RAI 03.07.01-27, Supplement 1, Revision 1**QUESTION:****Follow-up Question to RAI 03.07.01-19 (STP-NRC-100093)**

Revisions to COLA Section 3H.6

RAI 03.07.01-27, Supplement 2, Revision 1**QUESTION:****Follow-up Question to RAI 03.07.01-19 (STP-NRC-100093)**

Figure 03.07.01-27.25: Comparison of Horizontal Response Spectra at DGFOV 1A Basemat Top

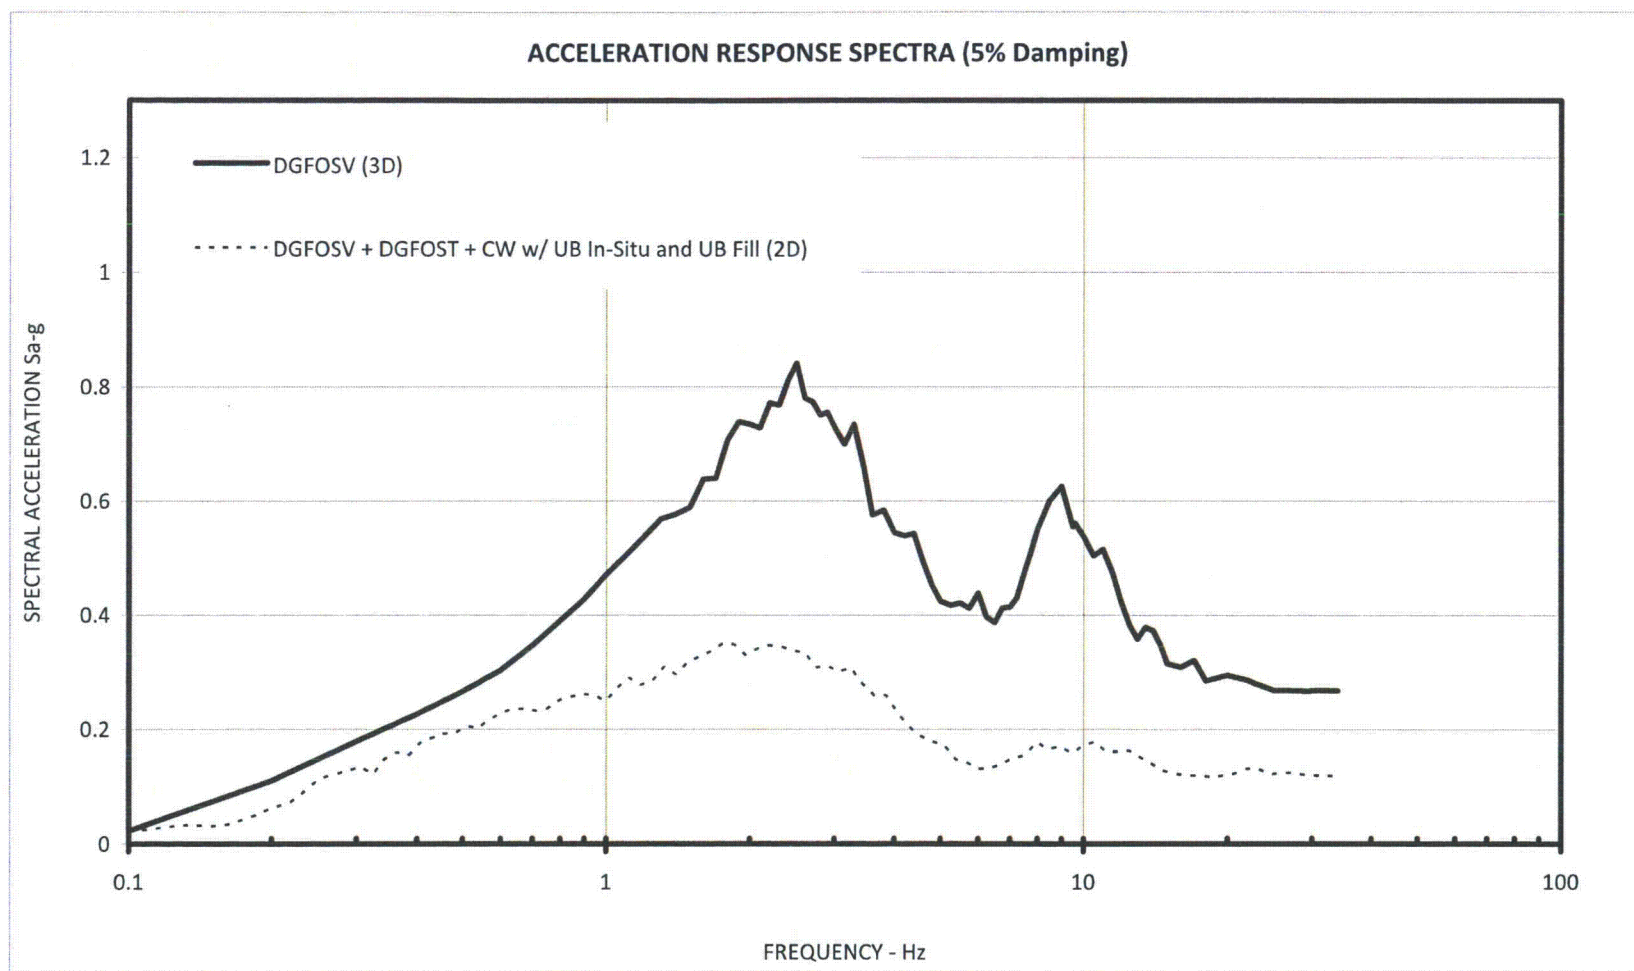
- (c) Demonstrate that the DGFOVS foundation response spectra and dynamic soil pressure (on DGFOVS basement walls using ASCE 4-98 criteria) used in the design of DGFOVS will envelop the results of structure to structure (SSSI) interaction analysis which explicitly models DGFOVS structure in the SSI model of RB and the RSW Pump House structure.

Figures 03.07.01-27.25, 03.07.01-27.26 and 03.07.01-27.27 show the comparisons between the DGFOV foundation level 5% damped response spectra obtained from the 3D SSI analysis (enveloped for all soil cases and used for the design of the DGFOV) and the 5% damped foundation spectra obtained from 2D SSSI analyses. The comparisons show that the design spectra obtained from the 3D SSI analyses envelop the spectra obtained from the 2D SSSI analyses. Note that the input motion for the 3D SSI analysis corresponds to 0.3g Regulatory Guide 1.60 spectra, and the input motion for 2D SSSI analysis is the site specific SSE.

Figure 3H.6-221: Partial Site Plan

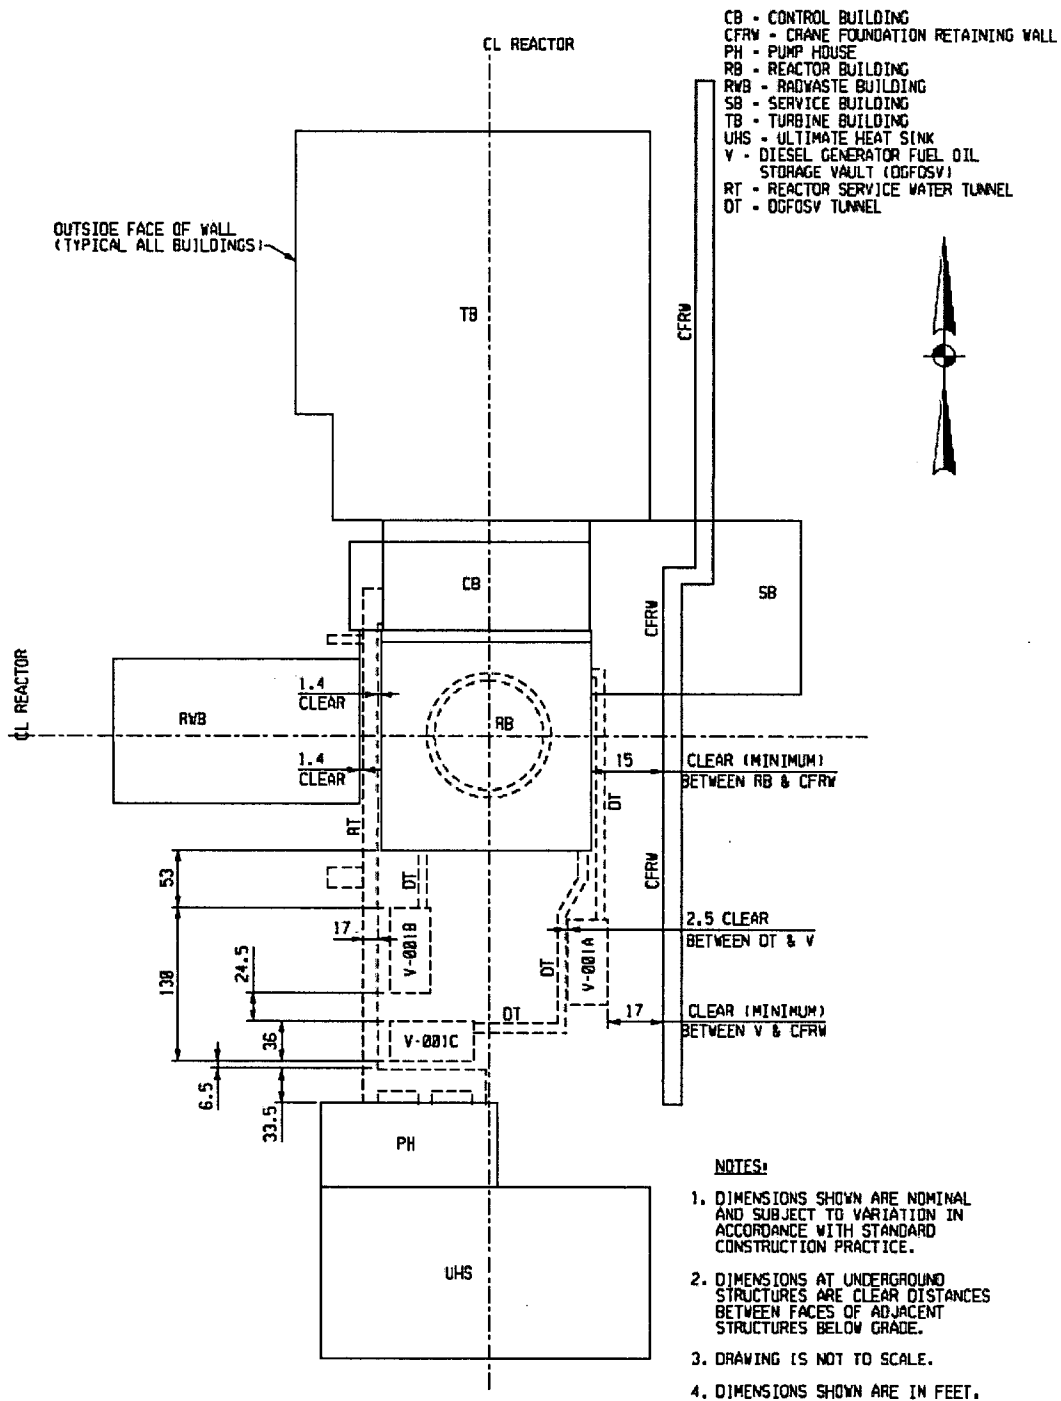
- (d) Describe in detail if there is any Category I tunnel structure for transporting Diesel Fuel Oil between DGFOVS and the Diesel Generator located in other buildings including its layout and configuration and seismic analysis and design method.

- 1(d). The layout of the Diesel Generator Fuel Oil Tunnels (DGFOTs) is as shown in COLA Part 2, Tier 2 Figure 3H.6-221 provided in response to Part 1(a) of this RAI. There are three (3) reinforced concrete DGFOTs approximately 50 ft, 200 ft, and 220 ft long for each unit. Each DGFOT is connected at one end to the Reactor Building (RB) and at the other end to a Diesel Generator Fuel Oil Storage Vault (DGFOSV). There is a seismic gap between each of the tunnels and the adjoining RB or DGFOSV. For magnitude of the required and provided seismic gaps at interface of DGFOTs and the adjoining RB and DGFOSVs, see the Supplement 1, Revision 1 response to RAI 03.08.04-31 which was submitted with NINA letter U7-C-NINA-NRC-110008 dated January 31, 2011.

Figure 3H.7-5: SSI, SSSI, ASCE 4-98 and Design Lateral Seismic Soil Pressures (psf) on Fuel Oil Tunnel East Wall with Reactor Building and Crane Wall

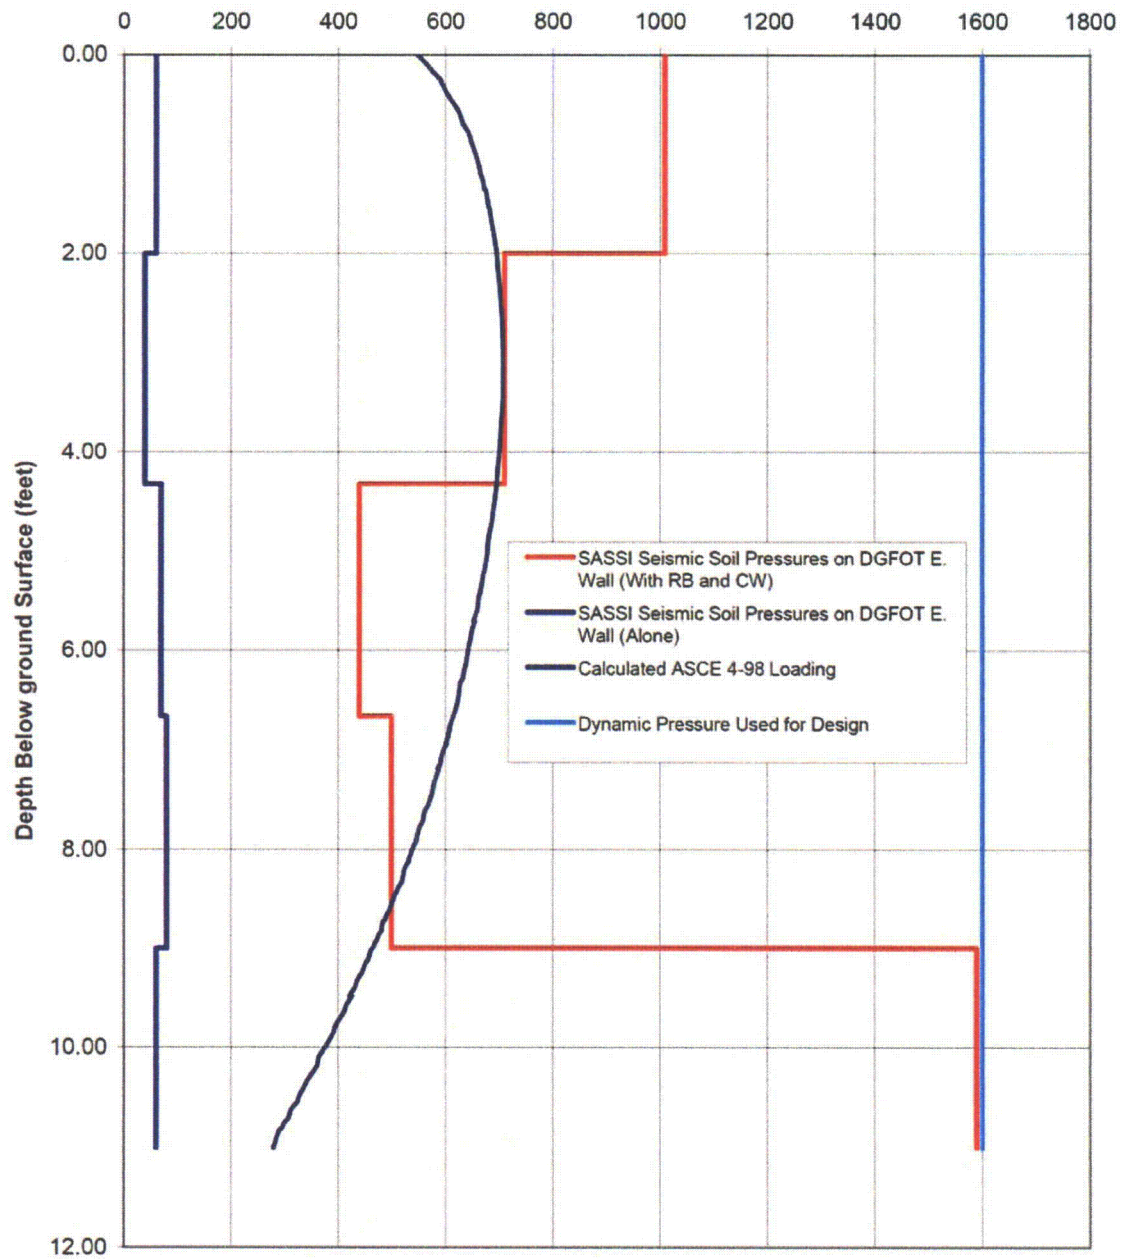
- (d) Describe in detail if there is any Category I tunnel structure for transporting Diesel Fuel Oil between DGFOVS and the Diesel Generator located in other buildings including its layout and configuration and seismic analysis and design method.

1. Clarify that the seismic soil pressures in Figures 3H.7-5 through 3H.7-8 are incremental seismic soil pressures.
2. Clarify how the induced seismic forces at the diesel generator fuel oil tunnel bends are combined with other seismic loads including seismic soil pressures.

Figures 3H.7-5 through 3H.7-8 show a comparison of the incremental SSI, SSSI, ASCE 4-98 seismic soil pressures and the enveloping incremental seismic soil pressures used for the design of the DGFOT walls.
